# RFB-2022-20 PRINCETOWN SHERIFF'S SUBSTATION RENOVATIONS & NEW CONSTRUCTION C2 DESIGN GROUP

## **ADDENDUM #3**

Issued Date: 03/08/2022

A901-L PLOT DATE: 3/9/2022 8:35:02 AM

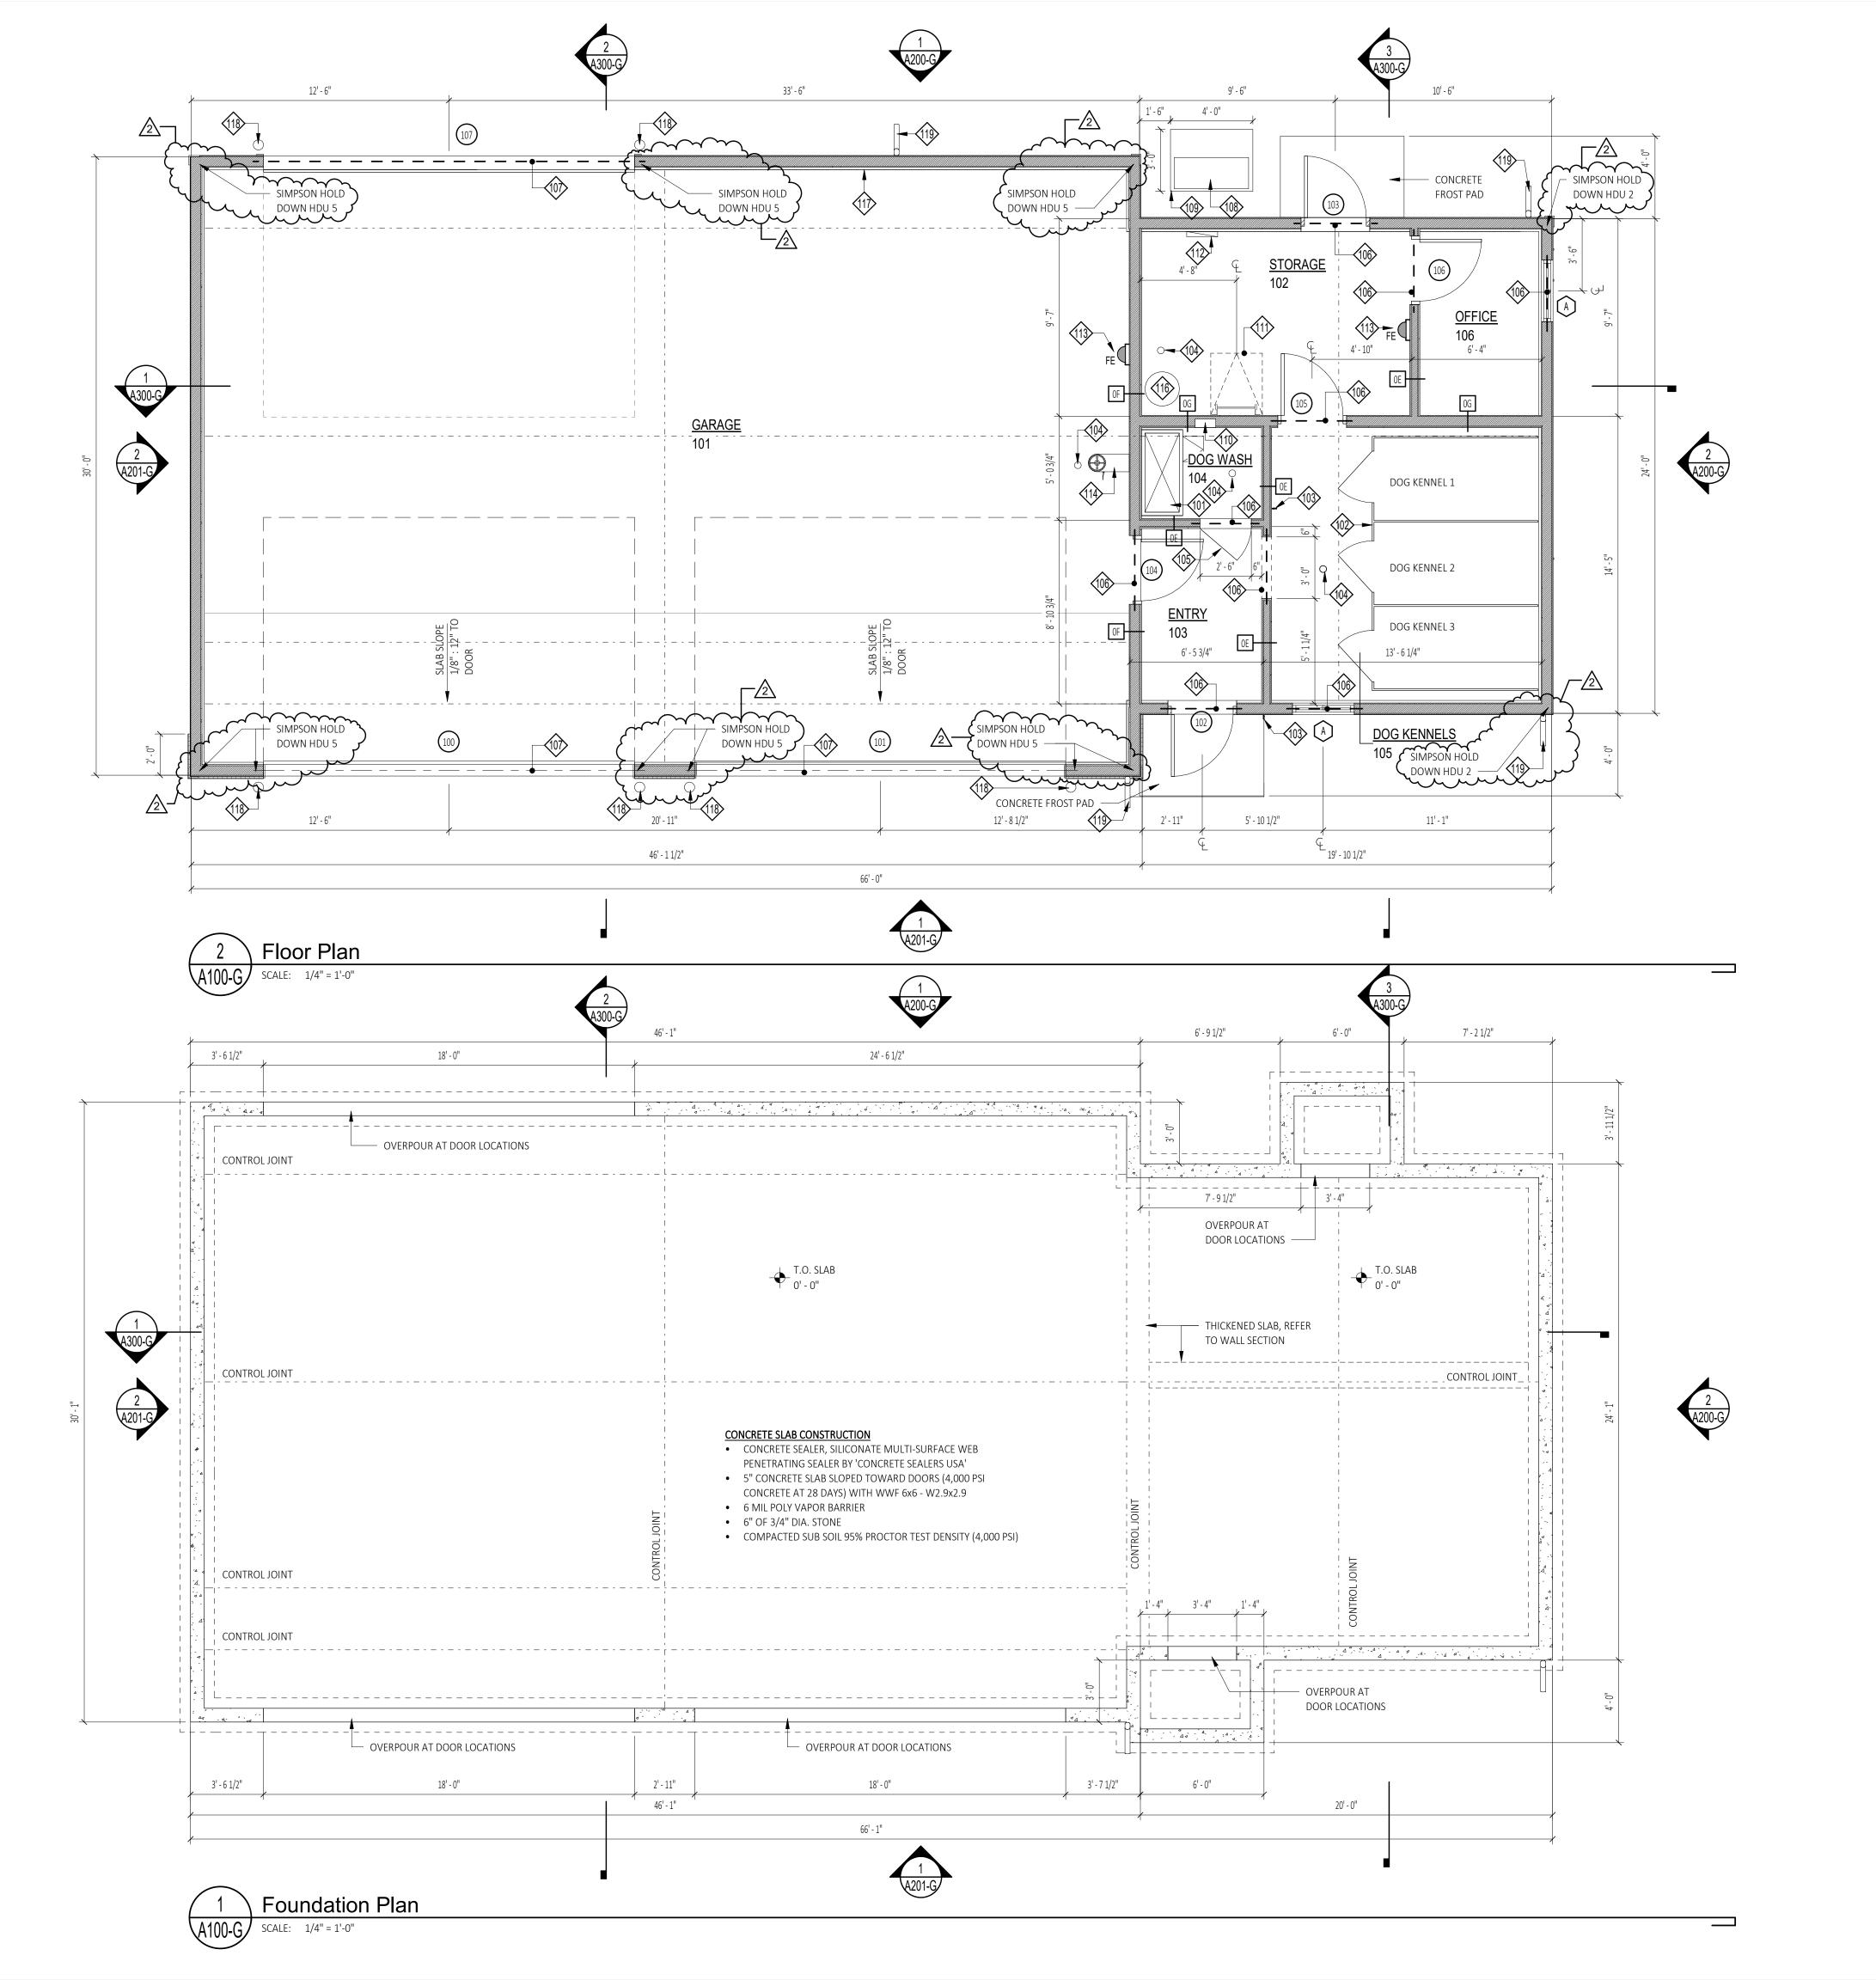
The finish schedule on sheet A901-L has been revised to indicate the ACT ceiling specification

Frost Pad Section at Exterior Door A600-G SCALE: 1 1/2" = 1'-0"

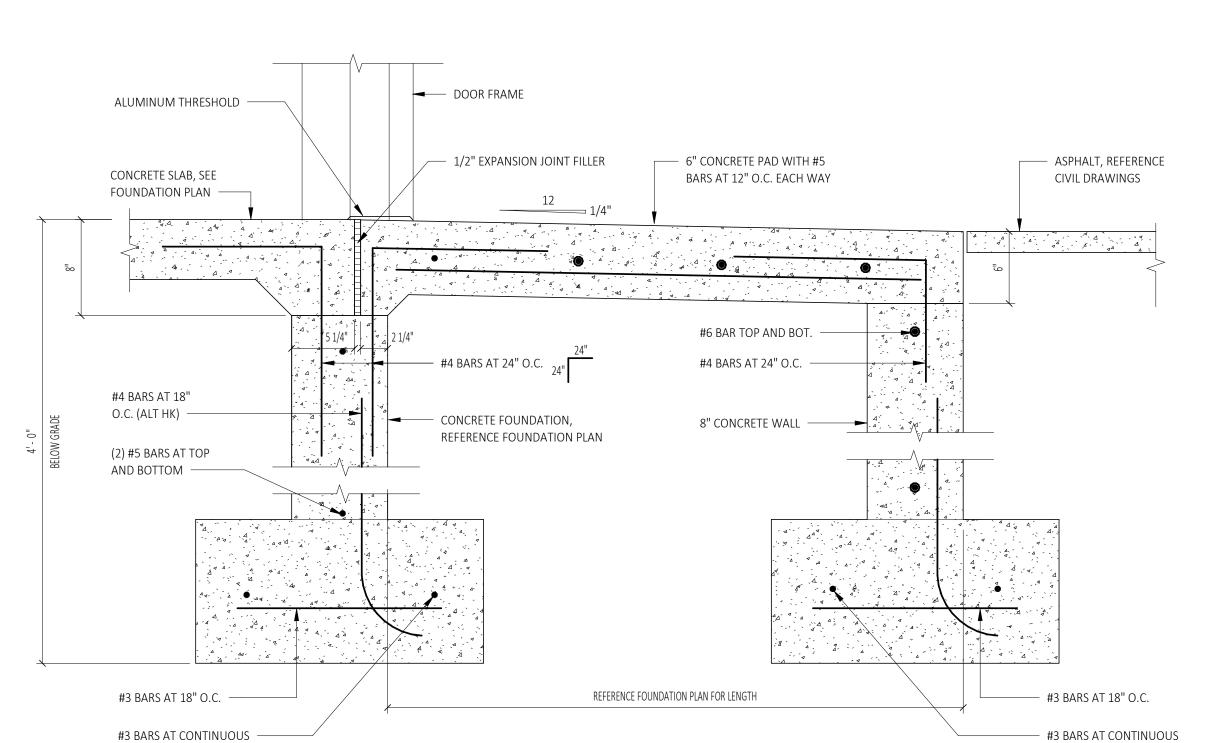
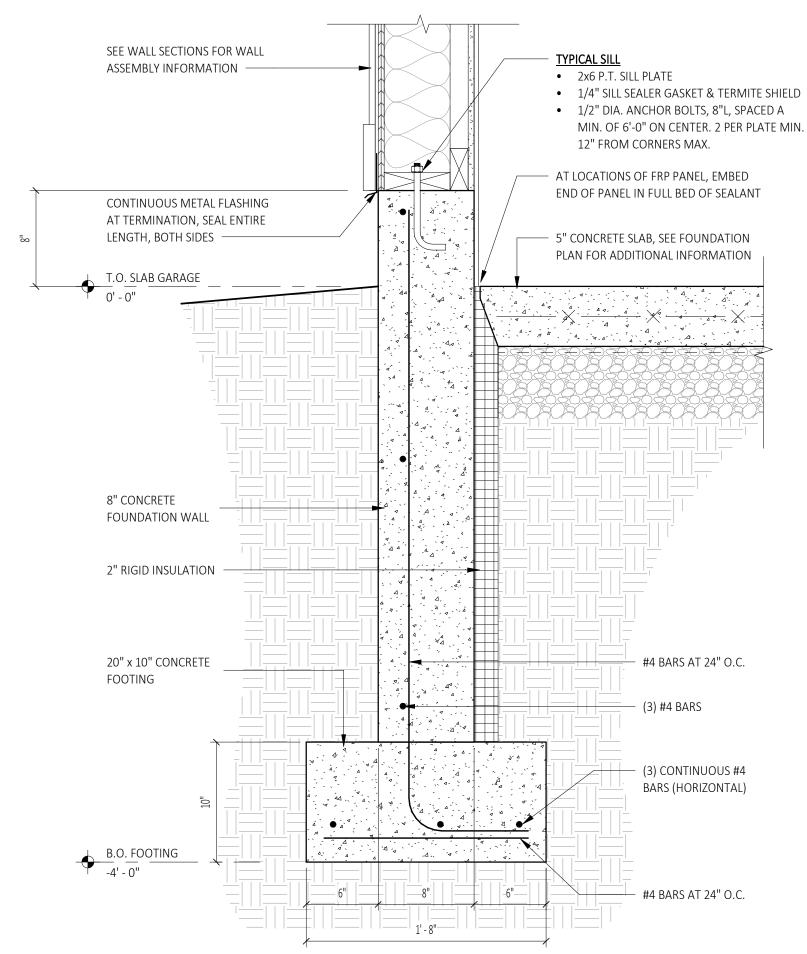
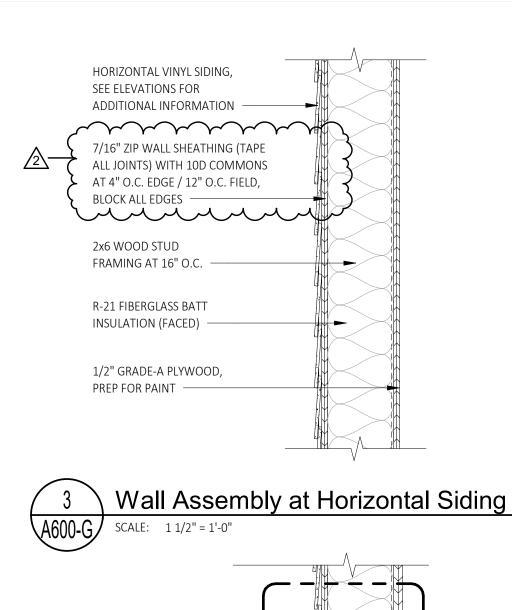
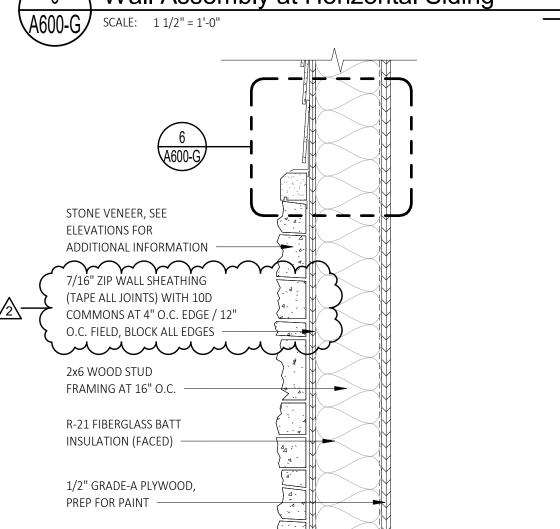
Shear wall locations and information has been provided on sheets A100-G, A600-G, A100-L, A101-L and A500-L.
